Service Bulletin

No.: MZ08-005

Model: SR4001, SR5001

Subject: Information on the addition of a Service extension cable.

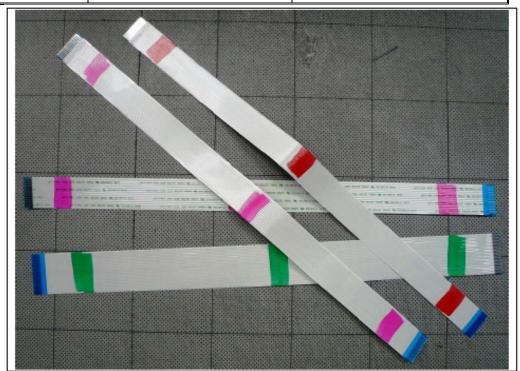
Symptom: The part number of Extension FFC will be added to the Service spare parts. The PWB can now be removed from the unit and repaired.

Solution: The Extension FFC comes in several types depending on the number of PINs and the length. That is why each comes marked in the same color with the location specified on the wiring diagram (below). Please check the attached wiring diagram before use.
